**TP310153 ELECTRICAL WIRE ASSEMBLY; TP180904 TERMINAL TAB;
TP180675 SCREW; TP144764, TP176700, AND TP158000 BASES;
ALSO TP199361 MODIFICATION KIT**

APPARATUS AFFECTED: 28A, 28B, 28D, 28E, 28F, 28G, 28G-1, 28H, 28J, 28J-1, 28K Perforator-Transmitter-Bases; TP144764, TP176700, and TP158000 Bases; TP199361 Modification Kit.

OBJECT: To insure a more reliable grounding arrangement and to facilitate connecting and disconnecting of the ground wire.

Fig. 1 - TP144764, TP176700 or TP158000 Base

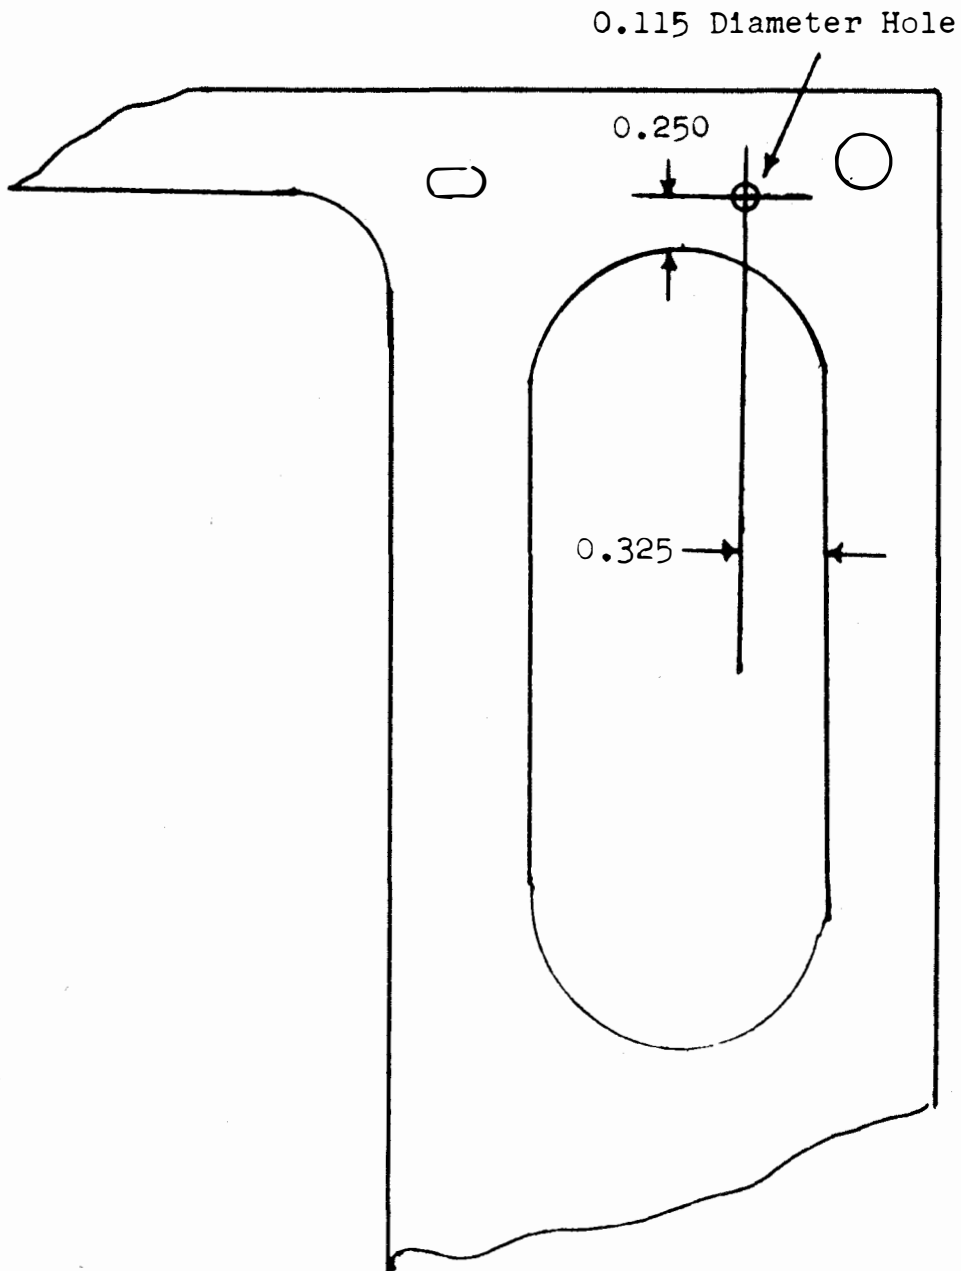
CHANGE: The TP144764, TP176700, and TP158000 bases have been modified by the addition of a 0.115 diameter hole (adjacent to the lower left motor mounting screw) for mounting a terminal tab by means of a self-tapping screw. See Figure 1.

The TP151569 ground strap connected between the TP158196 right base rail and the cabinet has been replaced with a TP310153 wire assembly consisting of 15 inches of No. 18 wire (green) equipped with a closed type lug on one end and a push type lug at the other end. The closed type lug mounts on the TP158682 plate (cabinet frame ground). The push type lug mates with the new TP180904 terminal tab mounted on the base.
